SAN ANTONIO WATER SYSTEM
Interdepartment Correspondence Sheet

Subject: Zoning Case Z2021-10700184 (Kyle Seale Parkway Multi-family)

Date: August 25, 2021

ZONING FILE: KYLE SEALE MULTI-FAMILY (FIGURE 1)
ZONING CASE: Z2021-10700184

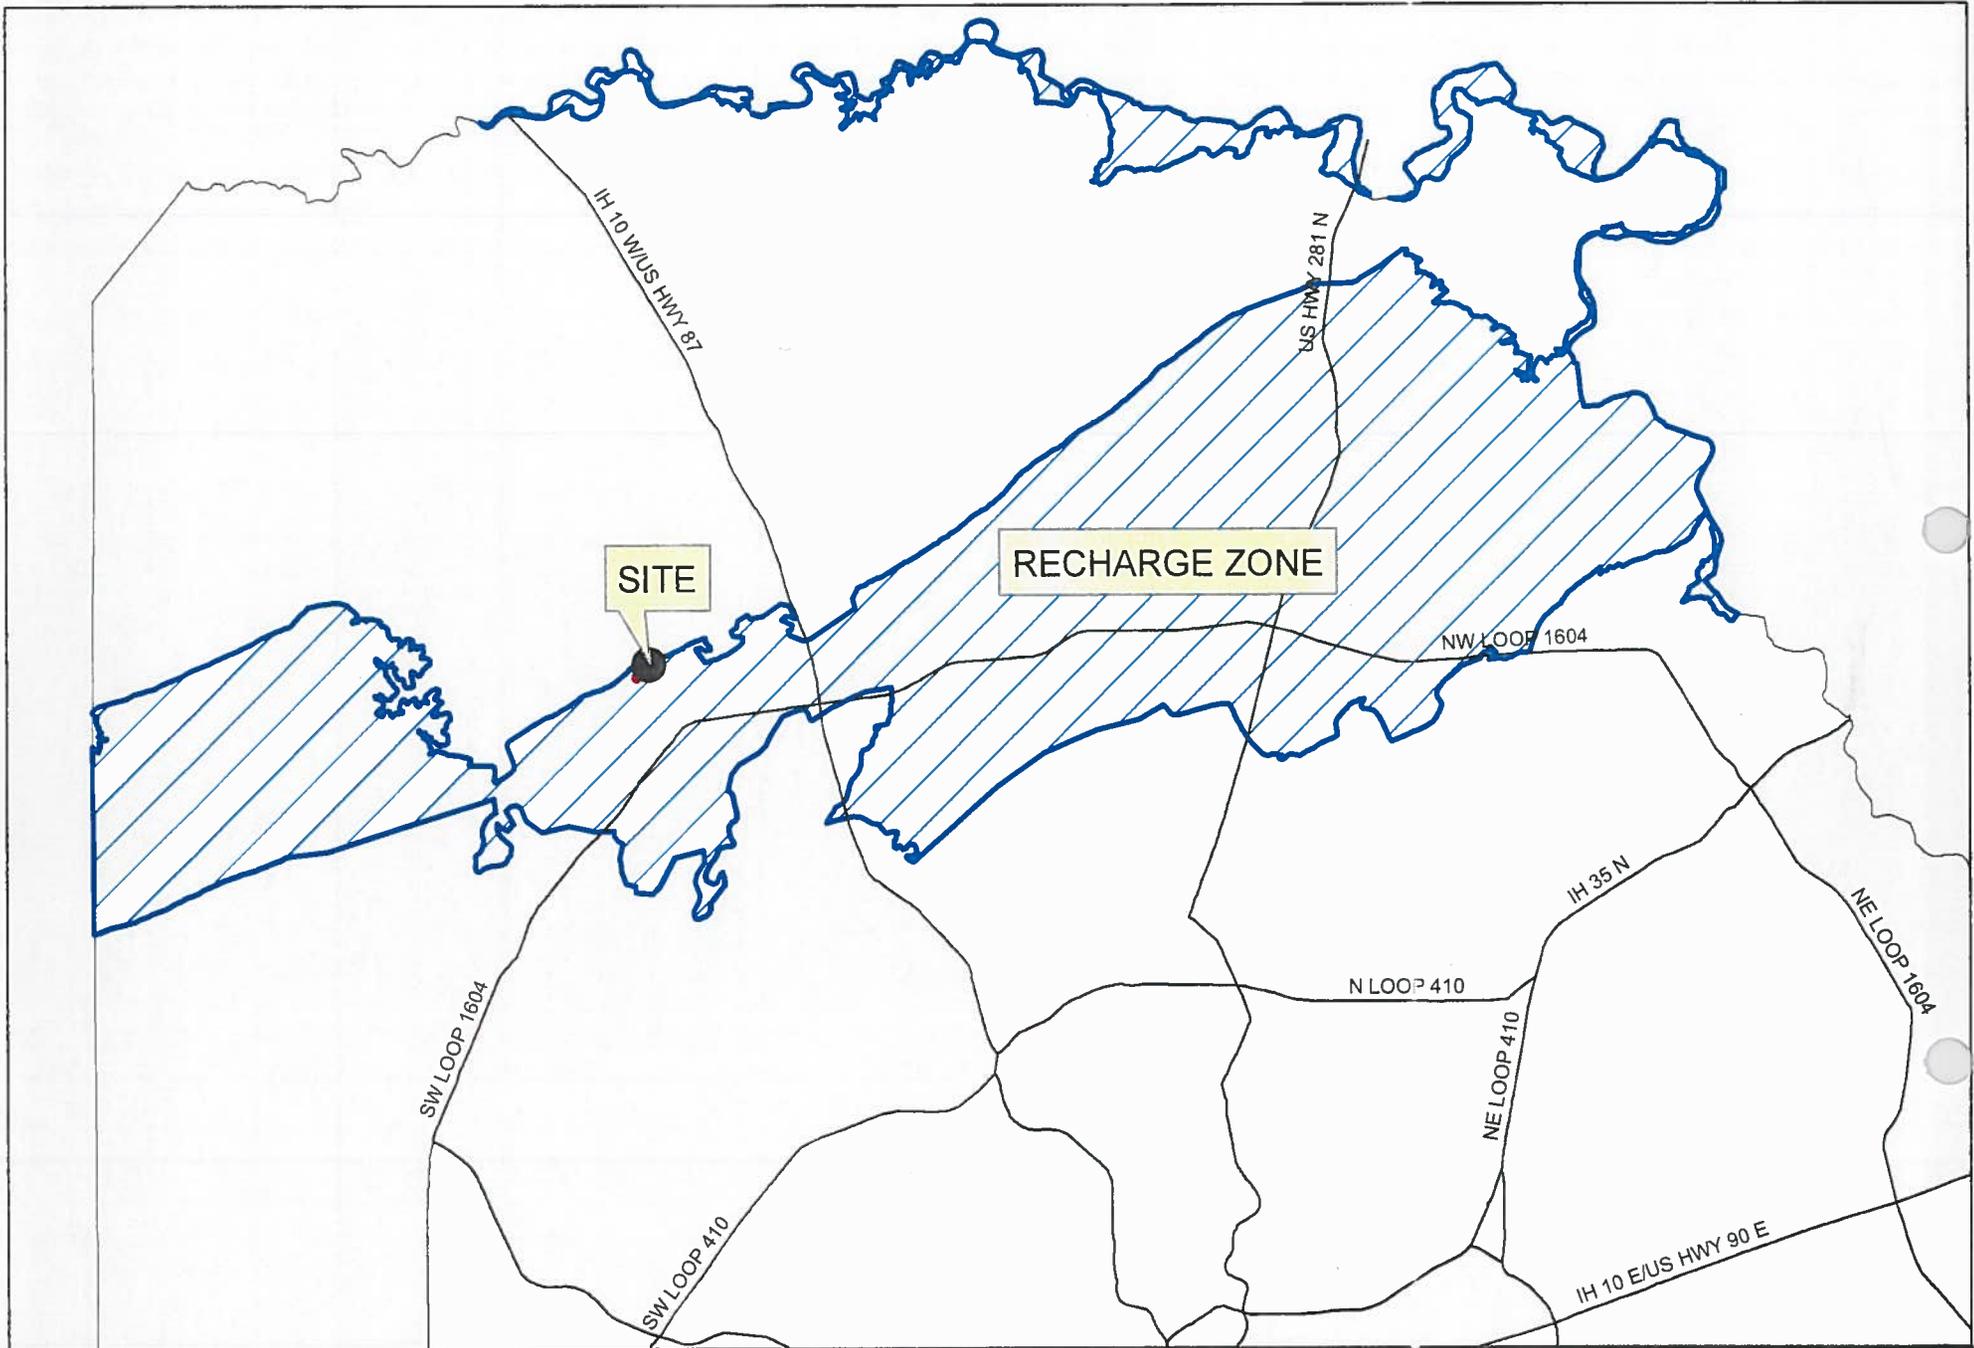
The subject property is in City Council District 8, approximately 1.5-miles north of Kyle Seale Parkway and North Loop 1604 West intersection. Approximately, 18.40-acres of the property lies in the Edwards Aquifer Recharge Zone with the remainder of the 1.60-acres in the Contributing Zone (Figures 1 and 2).
